TECHNICAL SERVICE BULLETIN

ISSUE DATE:	11/11/2021
SERVICE BULLETIN SUBJECT:	BCT Horn Mux 1.2 Pin Relocation Retrofit
VINs or MODELS AFFECTED:	Service Specified Buses
COMPLETE BY:	Next Service Opportunity
SERVICE BULLETIN #:	SC-21-162
LABOR OPERATION CODE:	EN50Z

BCT HORN MUX 1.2 PIN RELOCATION RETROFIT

MUX 1.2

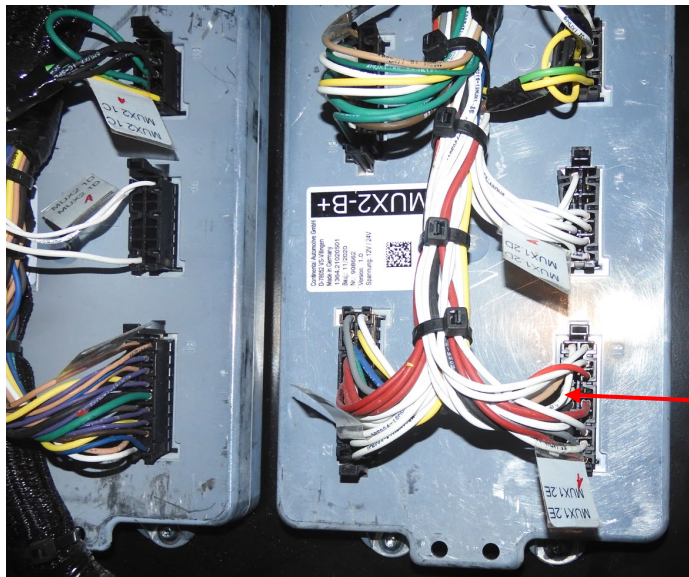
1. Complete the Proterra approved Lockout/Tagout procedure to make the bus safe for work.
2. Open the Streetside Wheel Well Box and locate MUX 1.2.

3. Locate the connector labeled MUX1.2E shown in the following photograph.

4. Disconnect the connector labeled MUX 1.2E.
5. Using a Pin Extractor Tool, remove the Pin in Cavity 6 of the Connector.
6. Install the Pin that was removed from Cavity 6 into Cavity 8 of the Connector.
7. Reconnect the Connector to the MUX.
8. Remove the Lockout/Tagout devices and return the bus to service.
